Proposal for Supplement 12 to the 04 series of amendments to Regulation No. 44 (Child restraint systems)

Submitted by the Working Party on Passive Safety *

Supplement 12 to the 04 series of amendments to Regulation No. 44 (Child restraint systems)

Annex 6, paragraph 3.1.5, Table 1, amend to read:

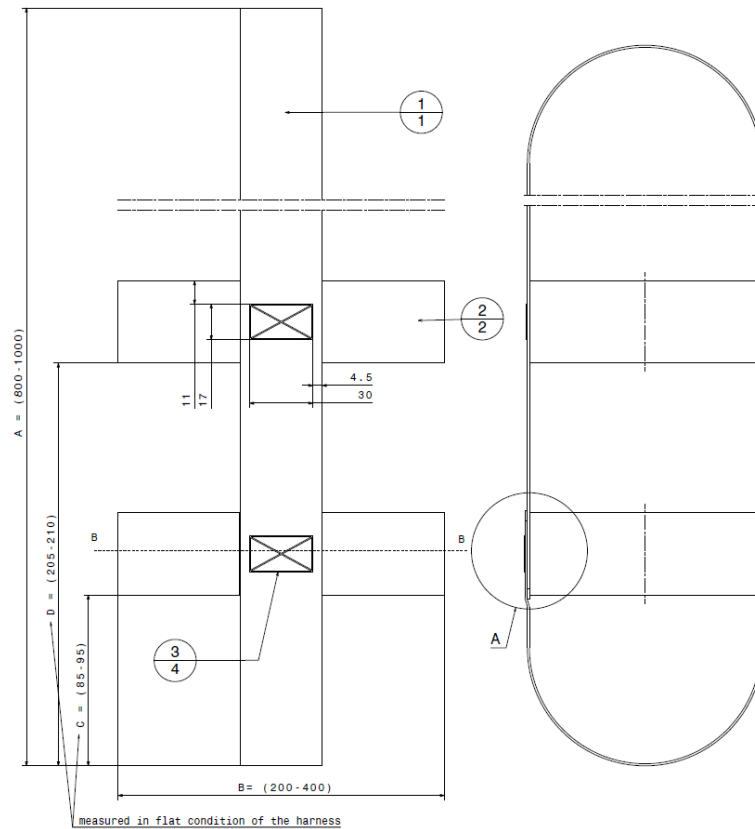
Density according to ISO 485 (kg/m ³)	40 -0/+5
Bearing strength according to ISO 2439B (N)	
p - 25 percent	125
p - 40 percent	155
Bearing strength factor according to ISO 3386 (kPa)	4
Elongation at rupture according to ISO 1798 (percent)	180
Breaking strength according to ISO 1798 (kPa)	100
Compression set according to ISO 1856 (percent)	3

Figure 1

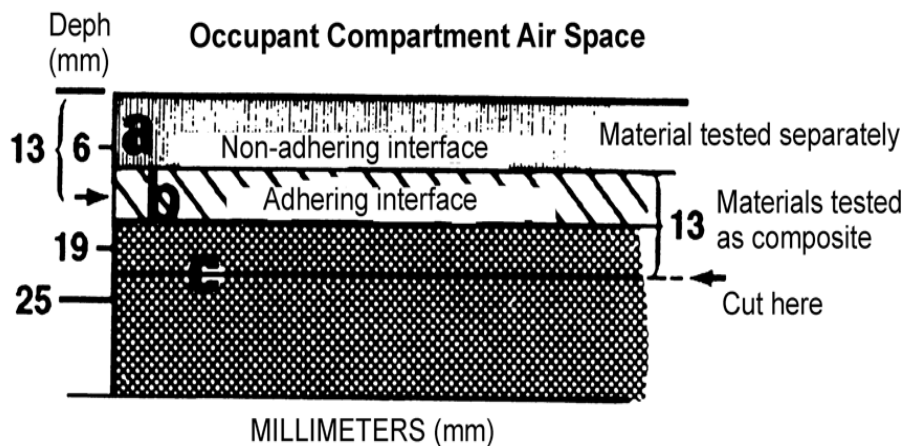
“Occupant compartment air space” means the space within the occupant compartment that normally contains refreshable air.
2. Material selection (see Figure 1 below)
 - 2.1. Any portion of a single or composite material which is within 13 mm of the occupant compartment air space shall meet the requirements in Paragraph 6.1.6.
 - 2.1.1. Any material that does not adhere to other material(s) at every point of contact shall meet the requirements of Paragraph 6.1.6. when tested separately
 - 2.1.2. Any material that adheres to other materials at every point of contact shall meet the requirements of Paragraph 6.1.6. when tested as a composite with the other material(s).

Material A has a non-adhering interface with material B and is tested separately.

Part of material B is within 13 mm of the occupant compartment air space, and materials B and C adhere at every point of contact; therefore, B and C are tested as a composite.

The cut is in material C as shown in Figure 1, to make a specimen 13 mm thick.
